APPARATUS AFFECTED: All 33 Call Control Units except UCC21 and UCC22.
All 35 Call Control Units.
35G, 35H, 35M, 35N, 35P, 35R, 35AA, 35AH and 35AL Electrical Service Units.
35AT, 35AU, 35AW, 35BC, 35BD, 35BE, 35BF, 35BG, 35BH, 35BP and 35BR Teletypewriter-Sets (Electrical Service Unit).
TP197041, TP199360, TP301651, TP304922, TP311076, TP319257, TP320255 and TP328098 Power Distribution Assemblies.

PART AFFECTED: TP178831 Receptacle Connector
TP178832 Adapter Plate
TP181240 Screw W/Lockwasher
TP182710 Upper Bracket
TP186426 Bracket
TP186628 Upper Bracket
TP197078 Mounting Plate
TP319258 Mounting Plate

REASON: (1) To conform to latest Underwriters Laboratories requirements.
(2) To provide a legible warning label (100 W. MAX) near the receptacle connector.
(See SUPPLEMENTAL INFORMATION (1).)

TP301713 RECEPTACLE CONNECTOR

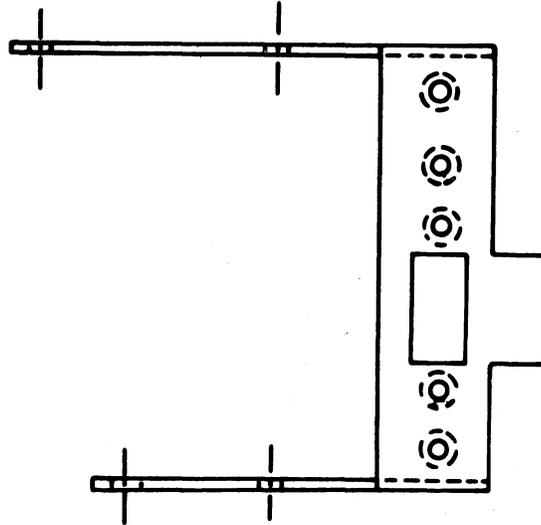
(1A) The TP178831 receptacle connector and TP178832 adapter plate are replaced by a new TP301713 receptacle connector. The TP182710 upper bracket is replaced by the new TP186628 upper bracket. The two TP181240 screws w/lockwashers which mount the above receptacle connector and adapter plate to the old TP182710 upper bracket are removed.

NEW TP186628 UPPER BRACKET

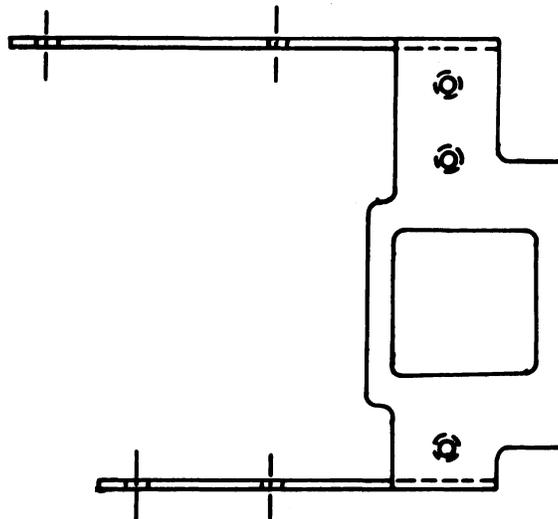
The TP186426 and TP186628 brackets and the TP197078 and TP319258 mounting plates (part of the above mentioned units and assemblies) are changed by replacing the steel stamped warning (100WATTS MAX) with a TP343470 label (100 W. MAX) to be affixed near the receptacle connector.
